**CITY OF CORONA  
DEPARTMENT OF WATER & POWER**

**SUBJECT: Notice Inviting Bids No. 21-071AS**

**Addendum No. 1**

**SDO Lift Station Coating Project on Palisades Drive North of Green River Road**

Exhibit A: Bypass and Flow rate map

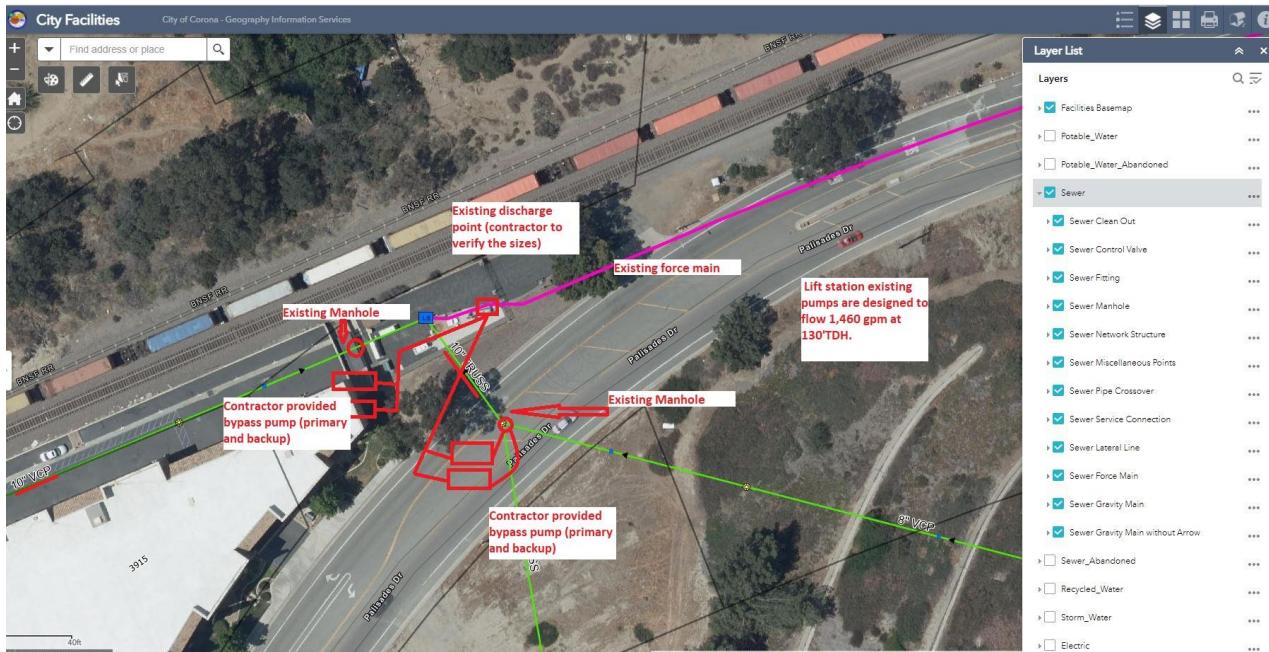
1.04 Section III, Technical Specifications are hereby deleted in its entirety and replaced with the Revised Section III, Technical Specifications. Special Conditions for Product Substitution Requests and Exhibit A - Bypass and Flow rate map have been added to the scope.

2.02 Question: "What is the sewage flow rate, in reference to the bypass?"

2.03 Question: "What is the redundancy required for the bypass?"

Response: *The existing pumps have the flow rate of 1,460 GMP @ 130' TDH. There are two (2) ten (10) inch gravity lines flowing into the lift station. The contractor is responsible for setting up bypass with back up pump at each manhole.*

Response: *Contractor must have primary and a secondary bypass pump for each gravity main flowing into the lift station.*
